10/583,219

Office Action Summary

DETAILED ACTION

FIG. 4

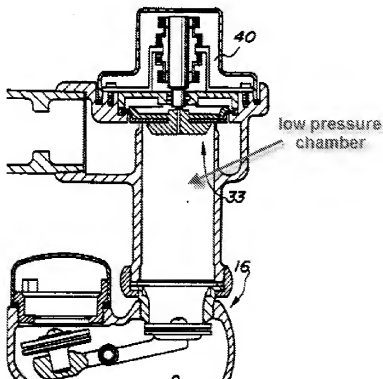
further comprising a first needle (44) coupled to the piezoelectric portion (45a), wherein the valve body (42, 12) is further defined by a first port (opening on top surface of valve member 33a which the first needle 44 sits on and blocks flow through), a low

pressure chamber (see labeled fig. 4 below), and a high pressure chamber (between the top surface of valve member 33a and member 43); the first needle portion (44) is moveable between a first needle open position and a first needle closed position; at least a portion of the first needle portion (44) is in contact with at least a portion of the first port (opening in top surface of valve member 33a) when the first needle (44) is in the first needle closed position, thereby defining a first boundary between the low pressure chamber and the high pressure chamber; and wherein the first valve member (33a), in the first valve member closed position, defines a second boundary between the low pressure chamber and the high pressure chamber;

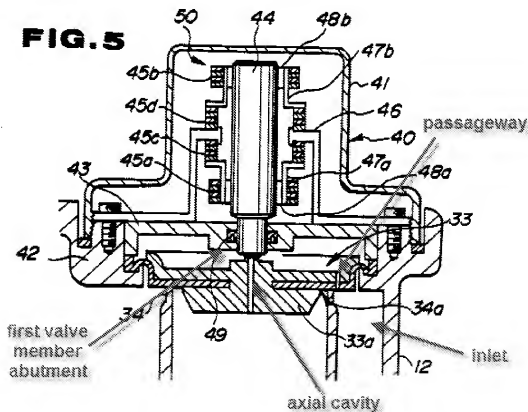
wherein the valve body member (42, 12) defines a first valve member abutment (see labeled fig. 5 below), and wherein at least a portion of the first valve member (33a) contacts at least a portion of the first valve member abutment (labeled fig. 5) when the first valve member is in the first valve member open position;

wherein the first valve member (33a) is defined by an axial cavity (see labeled fig. 5 above) formed therein;

wherein the first valve member (33a) is further defined by a passageway (see labeled fig. 5 above) connecting the cavity (labeled fig. 5) in fluid communication with the inlet (see labeled fig. 5 above);
